# Access Compliance Report

## Public Rights-of-Way

### (Curb Ramps)

Intersection ID: 18956	Main Street: N_I-77_EXIT_5_RA	Cross Street: TYVOLA_RD	Location:	N
ADA ID: 92861C44A2D1	Ramp Type: Perp	Initial Pass/Fail: Fail	Overall Compliance: No	Severity Score: 22.5
Codes/Mitigation Info/Possible Solution		Field Measurements/Component Compliance

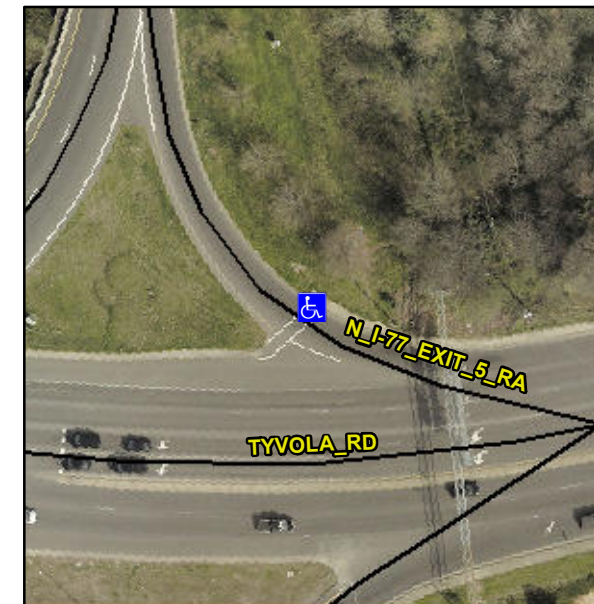
**Not Found, R304.5.1, R304.2.2**

Compliance	Description	Data	Compliance	Description	Data
N/A	Ramp Length (in)	60.0	No	Ramp Slope (%)	11.3
No	Ramp Width (in)	40.5	Yes	Ramp XSlope (%)	2.1
N/A	Flare Type LT	N/A	N/A	Flare Type RT	N/A
N/A	Flare Slope LT (%)	N/A	N/A	Flare Slope RT (%)	N/A
N/A	Flare Traversable LT?	N/A	N/A	Flare Traversable RT?	N/A
N/A	Landing Length (in)	N/A	N/A	DWS Provided?	N/A
N/A	Landing Width (in)	N/A	N/A	DWS Contrast?	N/A
N/A	Landing Slope (%)	N/A	N/A	DWS Length (in)	N/A
N/A	Landing X Slope (%)	N/A	N/A	DWS Full Width?	N/A
N/A	Landing Curb? (Y/N)	N/A	N/A	DWS Offset (in)	N/A
N/A	Shared Landing?	N/A			
N/A	Gutter Ponding?	N/A	N/A	Gutter Slope (%)	N/A
N/A	Gutter Lip Ht (in)	N/A	N/A	Gutter X Slope (%)	N/A
N/A	Painted X Walk1?	Yes	N/A	Painted X Walk2?	N/A
	X Walk 1 Direction	To SW		X Walk 2 Direction	N/A
N/A	X Walk 1 Width (in)	74.0	N/A	X Walk 2 Width (in)	N/A
	X Walk 1 Slope (%)	1.8		X Walk 2 Slope (%)	N/A
	X Walk 1 X Slope (%)	2.6		X Walk 2 X Slope (%)	N/A

**Remove & Replace Entire Ramp.**
